**Comanche Peak Nuclear Power Plant, Units 3 & 4
COL Application**

FSAR Revision 2

Update Tracking Report

Figure 2.5.1-229 Gas Production from the Newark East Field in the Barnett Shale

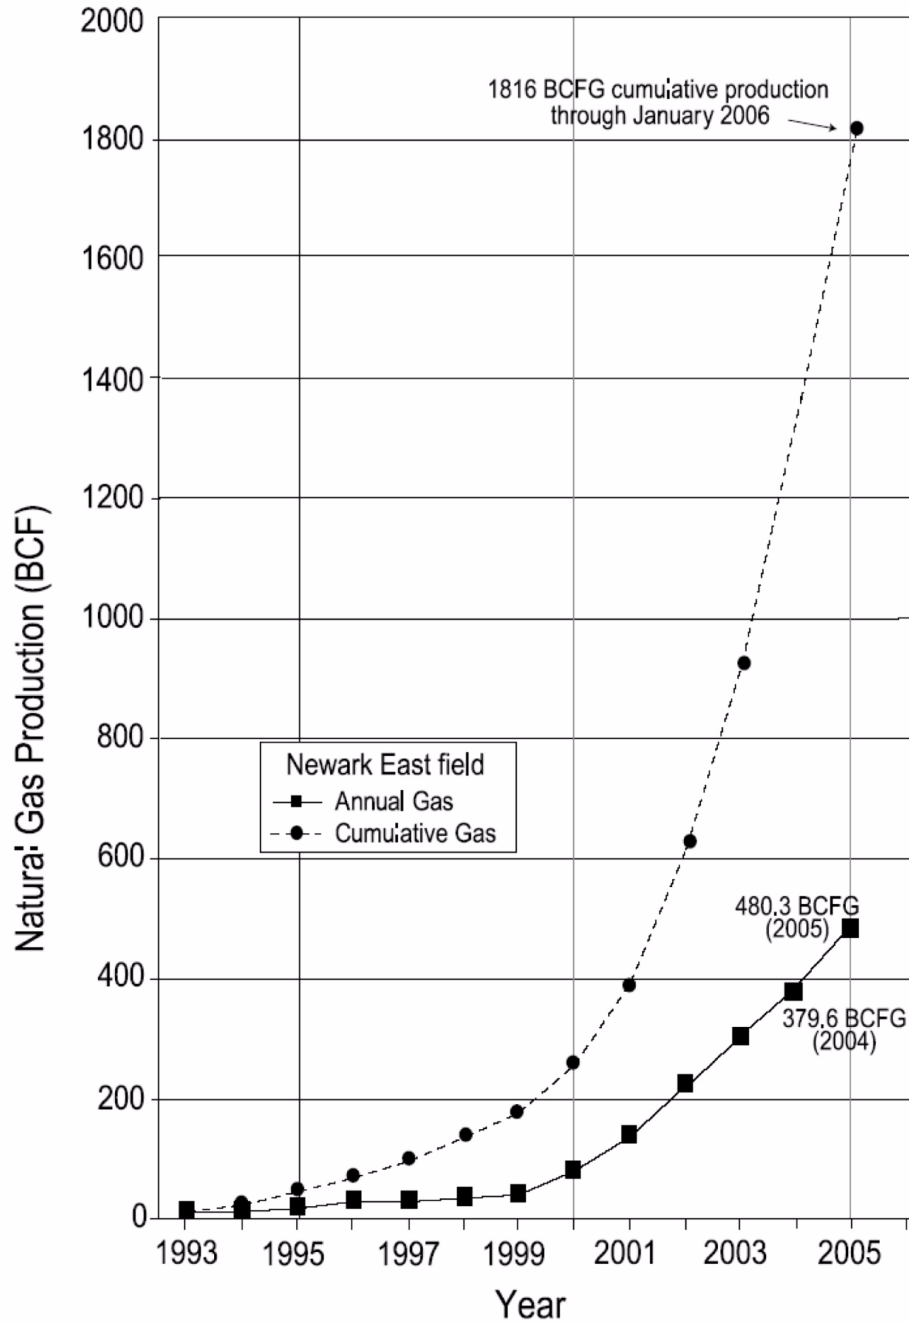
CTS-01417	Figure 2.4.7-201	-	Erratum	Corrected source, changed to Reference 2.4- 245	1
CTS-01414	Figure 2.5.1-229	-	Editorial	Revised the Note on the figure to correct “incresea” to ‘increase’ and “Poliastro” to “Pollastro”	1

Figure 2.5.1-230 1949 Historical Photograph

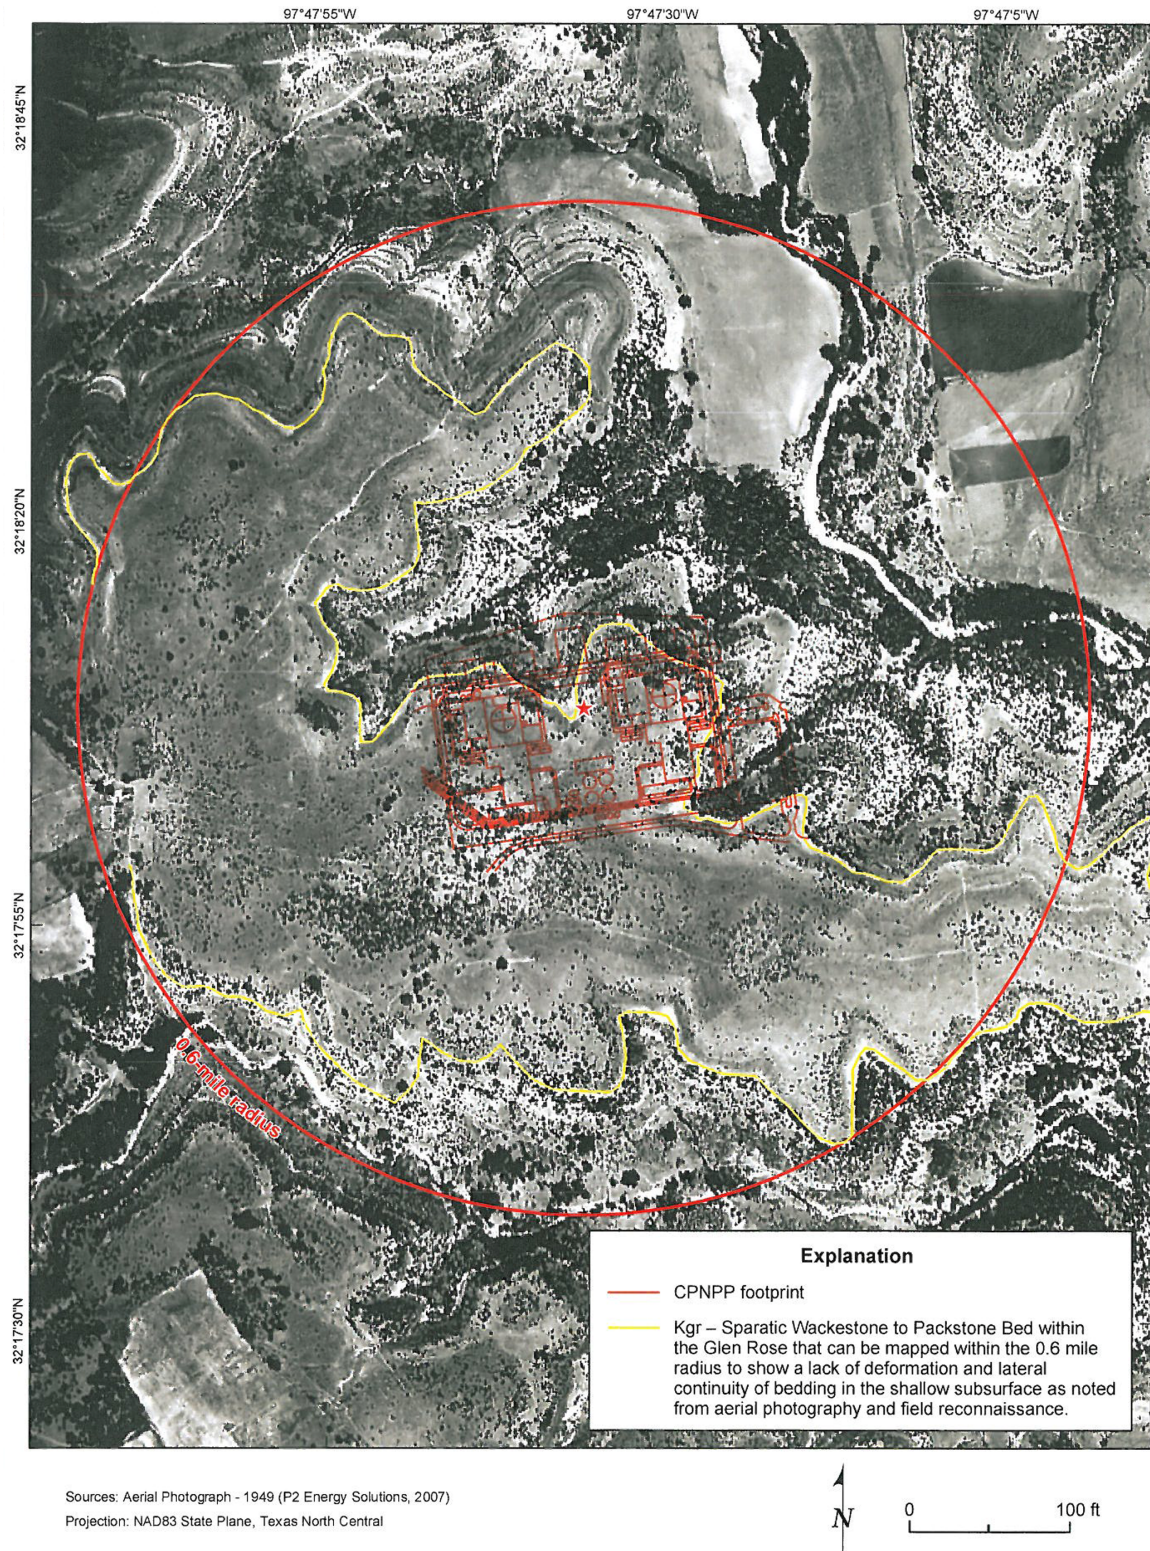
Change ID No.	Section	FSAR Rev. 2 Page	Reason for change	Change Summary	Rev. of FSAR T/R
CTS-01415	Figure 2.5.1-230	-	Editorial	Revised Explanation note on figure to correct typo; “subsurfaceas” was changed to “subsurfaces”.	1
CTS-01390	Figure 2.5.4-244	-	Editorial	Changed “Seismic earth pressure and compaction earth pressure not included” to “Seismic earth pressure not included” in Notes.	1

Figure 3K-201 Location of Flood Barrier Walls UHSRS, ESWPT, and PSFSV

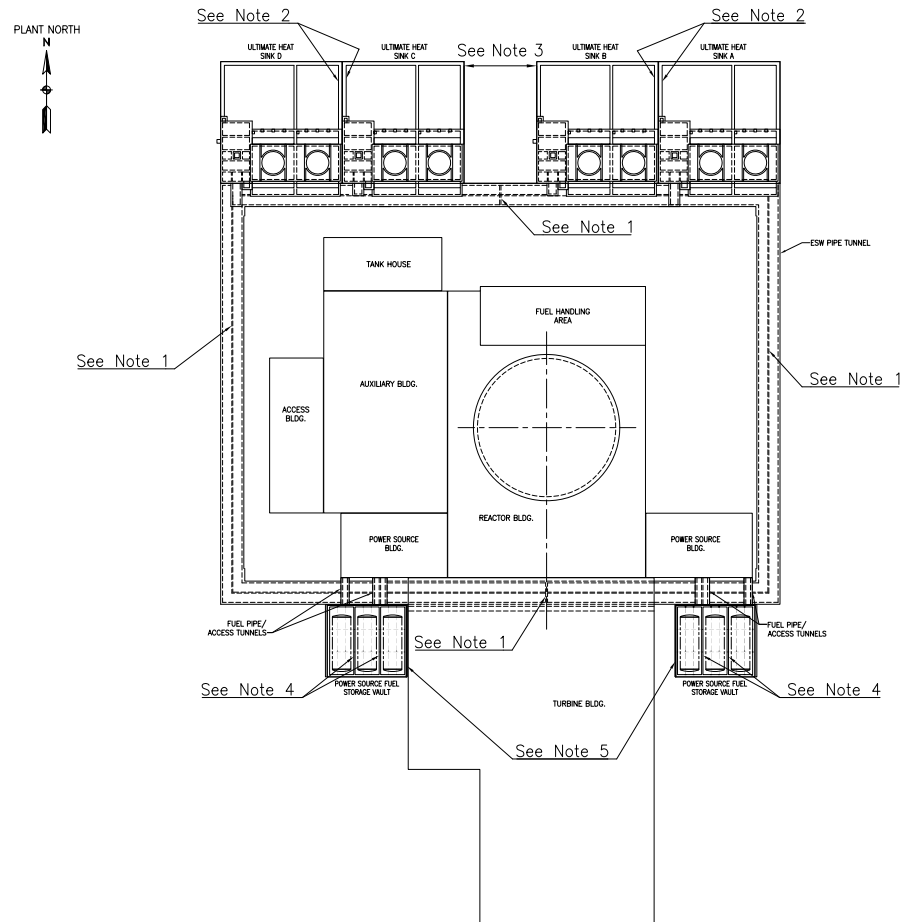
Change ID No.	Section	FSAR Rev. 2 Page	Reason for change	Change Summary	Rev. of FSAR T/R
	(New Subsection 3.12.5.10)	[3.12-2]	to DCD RAI No.742 Amend	3.12.5.10 and changed sentence in consistency with COL 3.12(5).	
DCD_03.12-25	3.12.7	3.12-2	Reflect response to DCD RAI No.742 Amend	Added COL 3.12(5) in consistent with DCD RAI response.	1
CTS-01394	3K 3K.1	3K-1	Consistency with DCD and R- COLA ITAAC	Added a new paragraph explaining the new Figure 3K-201.	1
CTS-01394	Figure 3K- 201 (New Figure)	3K-1 [3K-2]	Consistency with DCD and R- COLA ITAAC	Added a new Figure 3K-201.	1
CTS-01394	List of Figures (New)	3K-i [3K-ii]	Consistency with DCD and R- COLA ITAAC	Added LIST OF FIGURES due to addition of Figure 3K- 201.	1
